The rooms fit; some activities need their own space

Review against the consolidated daytime furniture and the concept 18 night arrangement

Service-end plan 1:35 at A3 | Amber outlines are temporary objects / users, shown together for location only

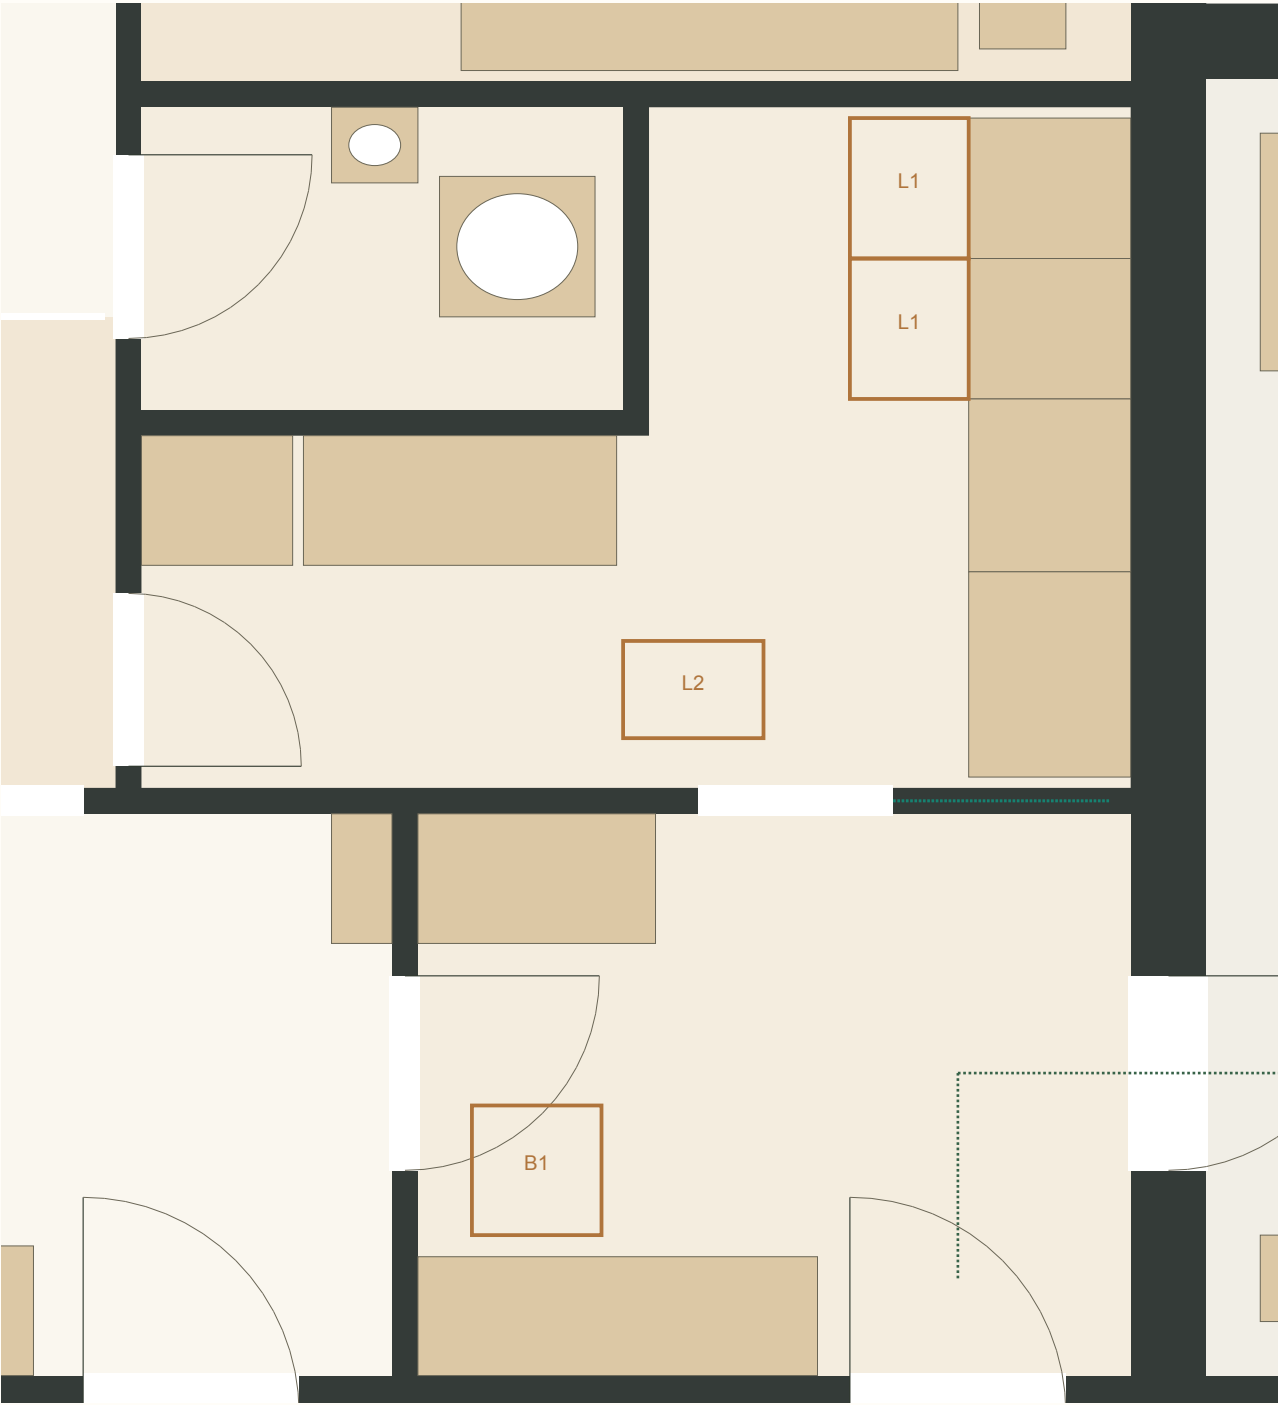
L1: each machine door projects 0.55 m into the aisle.
A 0.70 m sampled approach remains clear behind them.
L2: a 0.65 x 0.45 m basket obstructs the boot-to-laundry route.
L3: removing the basket restores the sampled route.
Basket storage under the counter is an operating proposal.

B1: a 0.60 m-square seated-person / knee reservation.
The original route to the gym passes too close to it.
Green: the alternative via the gym side clears the reservation.
This is a single moving person, not five people getting ready.
Coats, school bags and opening cupboard fronts need a mock-up.

The full laundry remains valuable. Option A plant would take away the counter / storage that helps keep this floor clear.

Kitchen / dining plan 1:40 at A3 | Additional end chairs and open dishwasher shown as temporary conflict tests

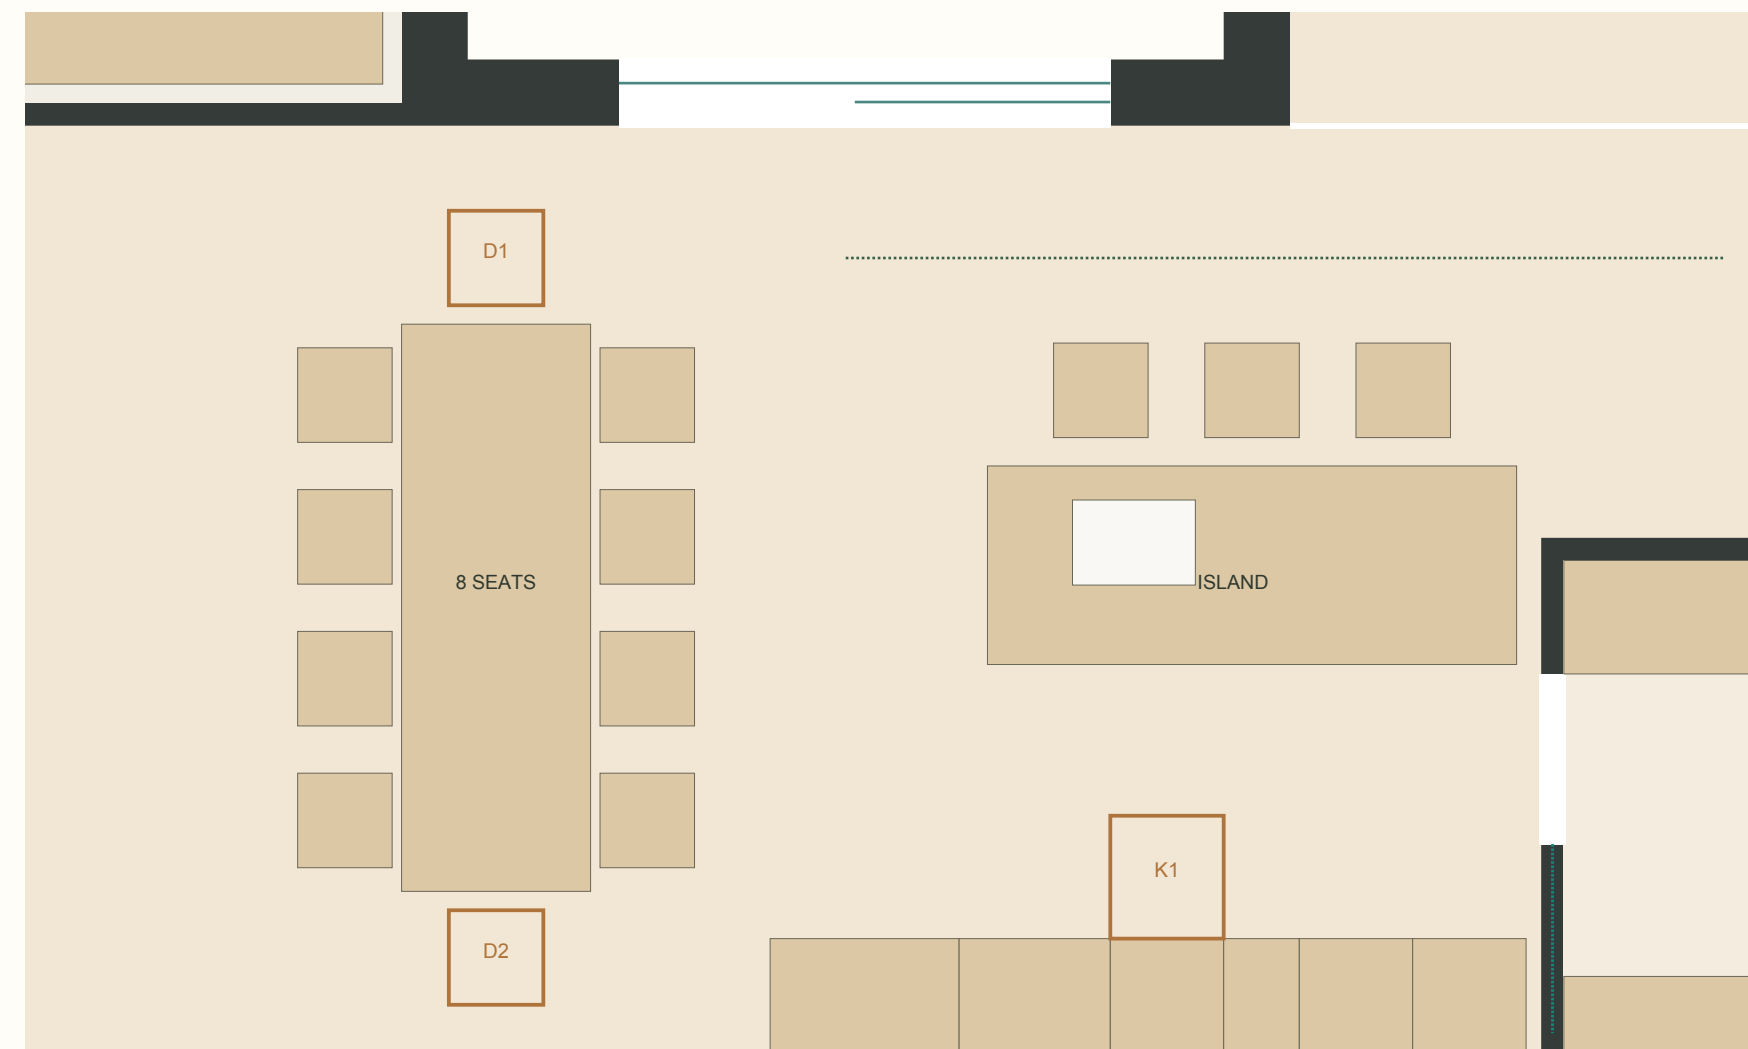
Current dining arrangement has eight seats.
Two extra 0.50 m chairs obstruct front / rear cross-routes.
There is no verified ten-place table arrangement yet.
Eight at the table plus two at the island is possible
as separate seating, not ten dining together.

0.65 m open-door projection tested.
The sampled cooking-aisle route is obstructed.
Green: courtyard-side passing route remains clear.
A person unloading adds another occupied area.
Selected appliance hinges and doors still need checking.

Keep the eight-seat dining arrangement as the current proposal. Do not silently add ten seats to a furnished drawing.
If ten at one table matters, develop table position, chair pull-out and both circulation edges as one measured change.
Two simultaneous high-flow showers remain a services requirement; geometry checks do not prove pressure or hot-water capacity.
No new partitions or furniture changes are adopted by this review. The JSON preserves all 12 reproducible scenarios.
